ADDENDUM NO. 1

March 17, 2022

STR Project Number 21051.01

Project:
D116 RLHS Theater AV Improvements
Round Lake High School
Round Lake High School Drive
Round Lake, Illinois 60073

1 UPPER LEVEL - ELECTRICAL PLAN
 SCALE: 3/16" = 1'-0"

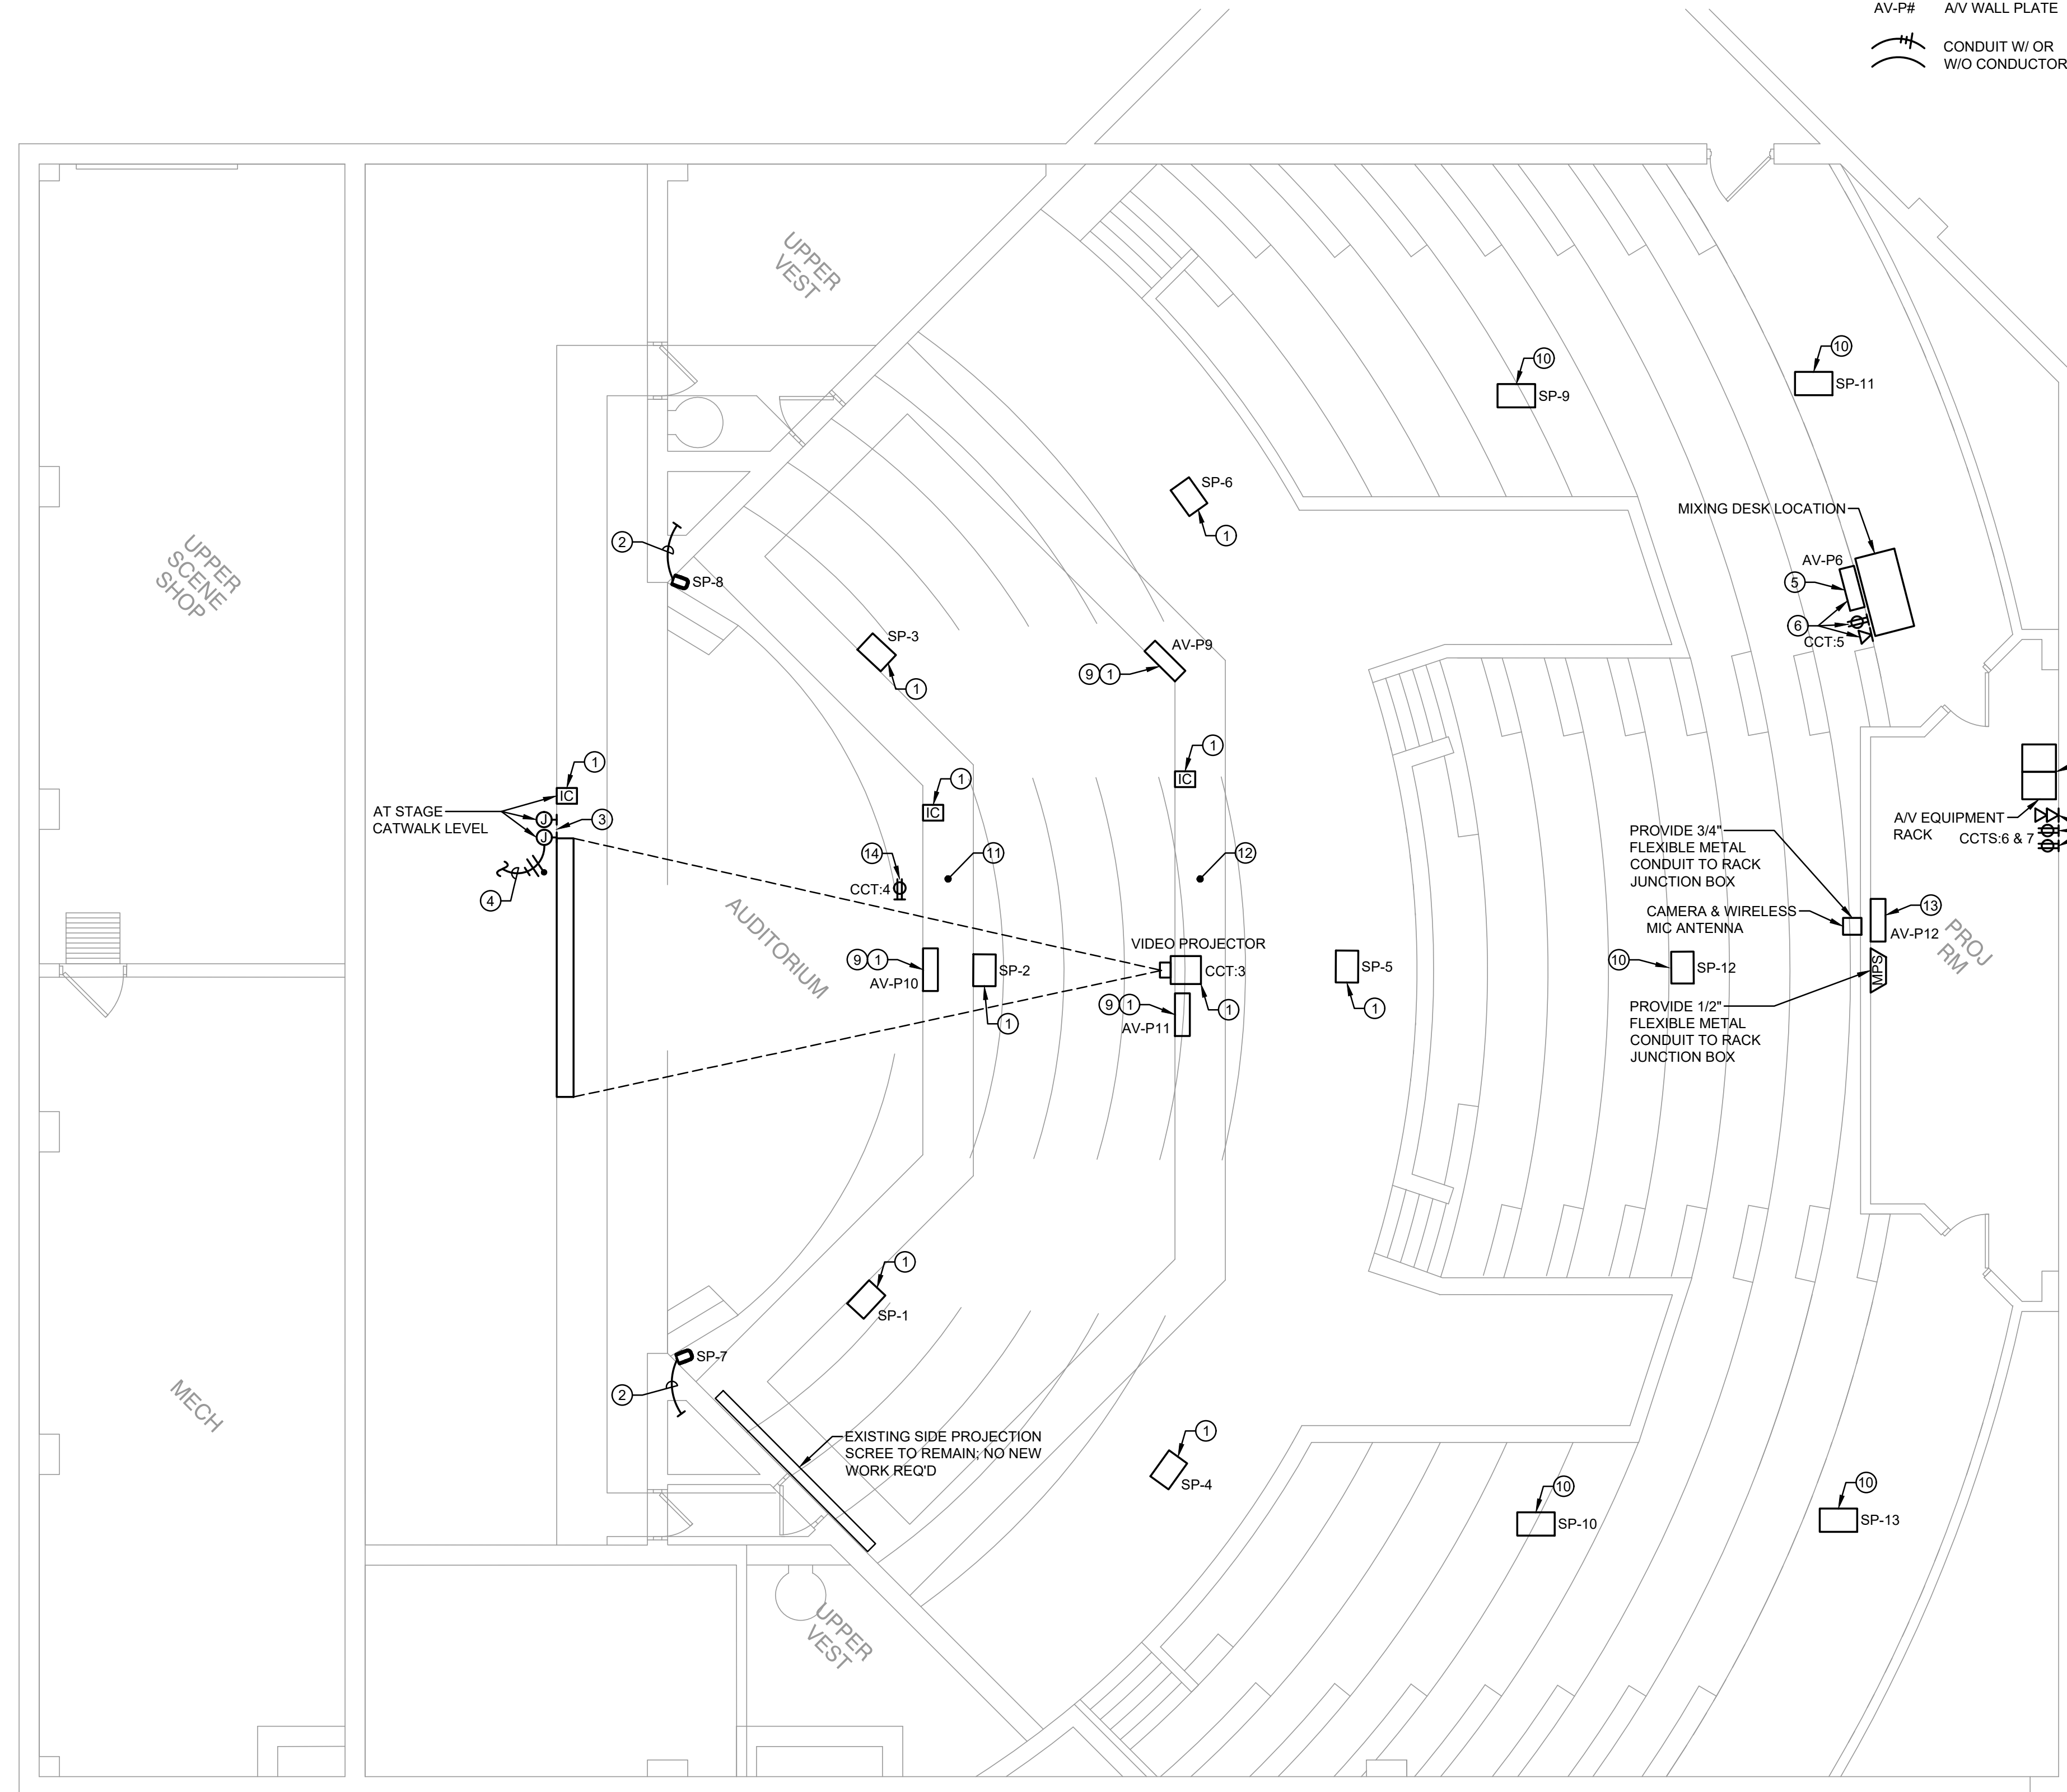
1. **Sheet E1.0, LOWER LEVEL - ELECTRICAL PLAN**
 - a. **CLARIFY** - Revised and added notes.
2. **Sheet E1.1, UPPER LEVEL - ELECTRICAL PLAN**
 - a. **CLARIFY** - Revised and added notes.
3. **Sheet E1.2, UPPER LEVEL - ELECTRICAL PLAN**
 - a. **CLARIFY** - Revised and added notes.

ALL EXPOSED CONDUITS IN THIS AREA SHALL BE PAINTED BLACK.
